Shire of Dardanup

Crooked Brook Structure Plan

Hydrological Review

June 2005

Figure 1: Crooked Brook Structure Plan Aerial (reproduced from Figure E of Graham Houghton (2004))

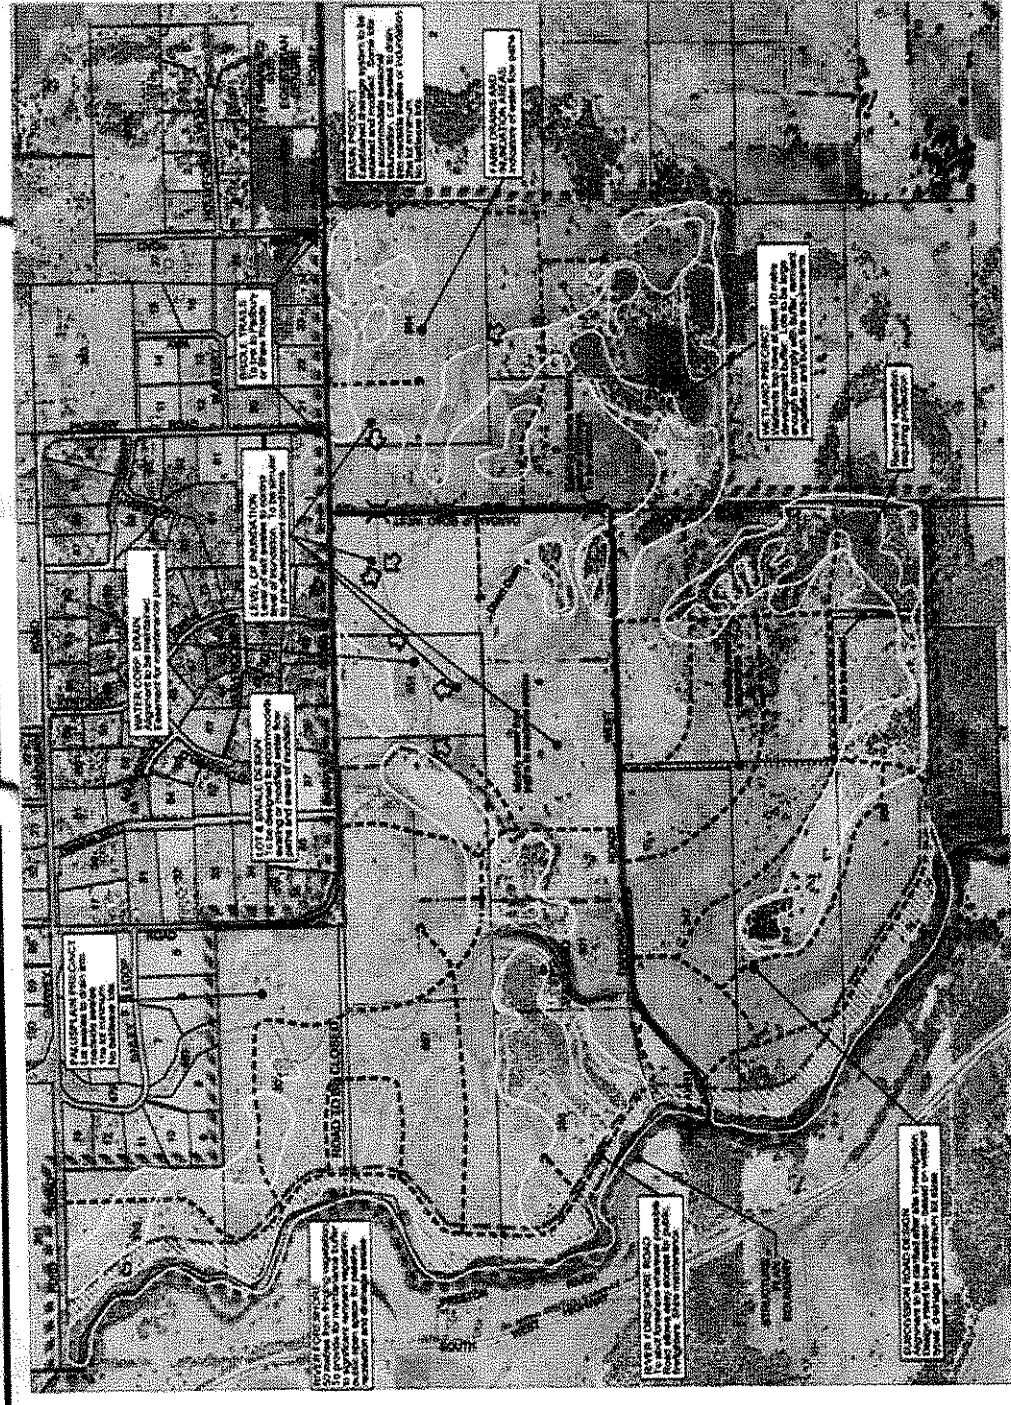
The Structure Plan noted the increase in amount of runoff that would need to be discharged compared to pre-development agricultural conditions as a result of impervious roads and access tracks, house pads and other built-up areas. It was identified that this additional water could be difficult to manage given the environment of low infiltration and limited capacity of the off-site discharge drains.

It was noted that several of the existing drains feeding directly into the Preston River which are west of the alignment of the Water Corporation north/south rural drain.

It was considered that this direct discharge is not "environmentally satisfactory" and it was proposed to allow stormwater discharge into swales in the proposed river foreshore.

The Structure Plan noted there is little existing roadside drainage along Garvey Road and Dardenup West Roads which would need to be upgraded at the sub-dividers expense. Roadside swales were proposed for internal sub-division roads to collect and slowly channel water towards the discharge point. The swales were to act as detention areas to attenuate the peak flow so that post-development flows do not exceed existing pre-development flows. It was noted that waterlogging would continue to occur over several months of winter and a notification on new titles created would be required to the effect that waterlogging and inundation may be experienced.

Existing flow paths into basins and from basins into drainage channels were proposed to be modified to create swales. Similarly swales along the Preston River Foreshore were proposed to discharge water into the river by pipes to lower erosion risk over the steep river banks.

With respect to water quality source controls to minimise pollutant inputs were recommended rather than nutrient stripping basins. The Structure Plan therefore did not recommend any new drains to be constructed to drain to the Preston River to alleviate the present waterlogging and inundation issues. Rather the philosophy was to create shallow surface drains (swales) which would slowly discharge surface water and provide flood storage during times of heavy rainfall.

JDA considers that there is an excess of surface water created largely by a perched water table reaching the surface in winter, which needs to be dealt with by additional drainage outlets to the Preston River.

Such new outlets should discharge safely after attenuation in detention basins to prevent erosion of Preston River banks.

Shire of Dardanup
West Dardanup
Figure 9: Proposed Post Development Drainage

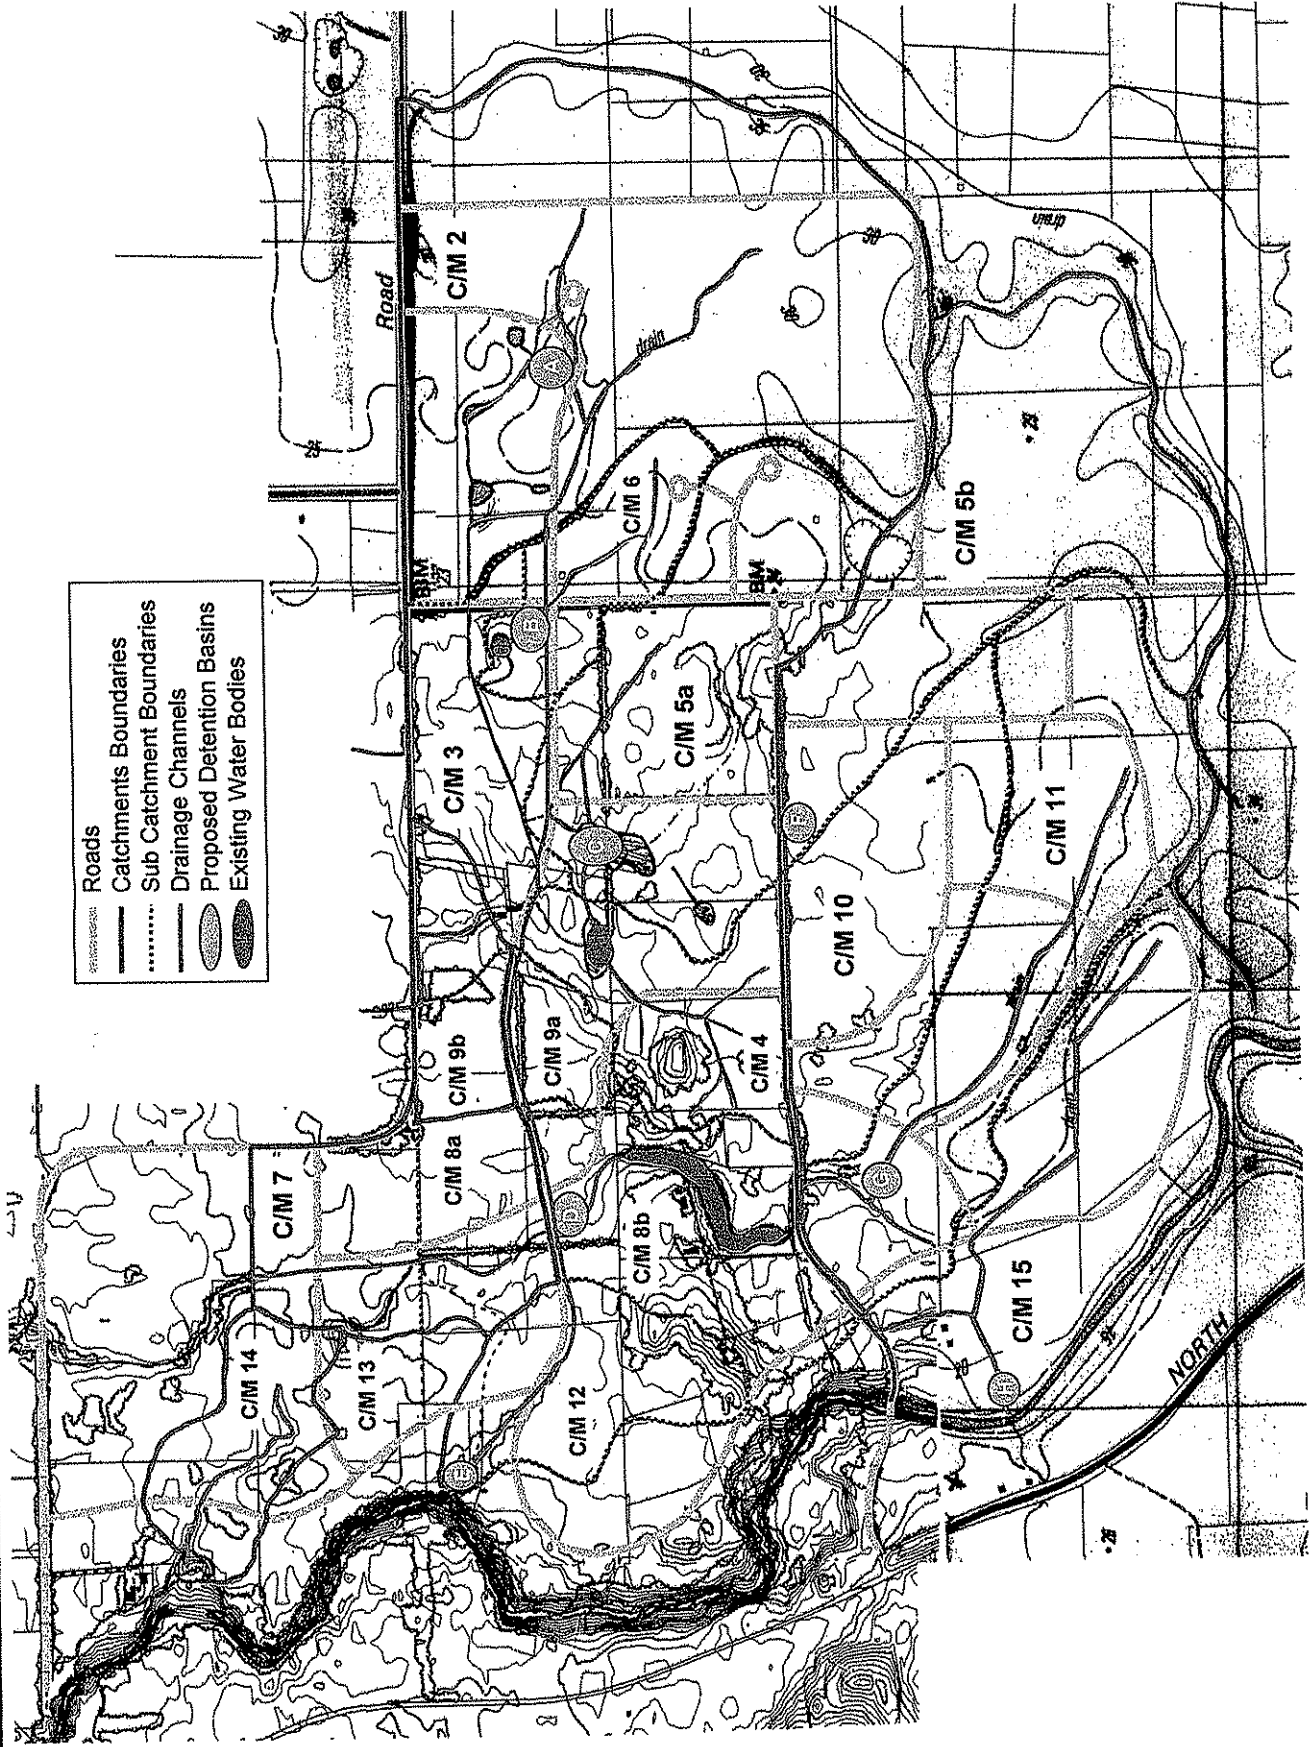
Both of these possible new drains are indicated on Figure 9 together with the surface catchments which they would serve. Also indicated on Figure 9 are tentative locations for surface water flood detention basins.

The drain along Dardanup West Road would capture all the catchments south of Dardanup West Road that currently drain to the Gavins Gully A Sub Branch. The drain along Garvey Road would capture all catchments between Garvey Rd and Dardanup West Rd and catchments east of Dardanup West Rd.

There are seven possible detention basin site, three for the southern Dardanup West Rd drain, and four for the central Garvey Rd drain. An eighth may be required for the northern section of the Gavins Gully A Sub Branch, and other smaller basins maybe required for the catchments discharging directly to the Preston River.

The proposed drainage system has been modelled in XP-STORM. Basins were sized so that no overflow occurs in basins or channels for the critical 10 yr ARI storm event. The downstream basins were sized so that post development outflow is less than or equal to pre development outflows. The proposed detention basin sizes are summarised in Table 3. Channels were assumed to be "V" channels with 1 in 3 side slopes, with maximum depth of 1 m. Exact profiles and geometry of the new drains will need to be considered at detailed design stage.
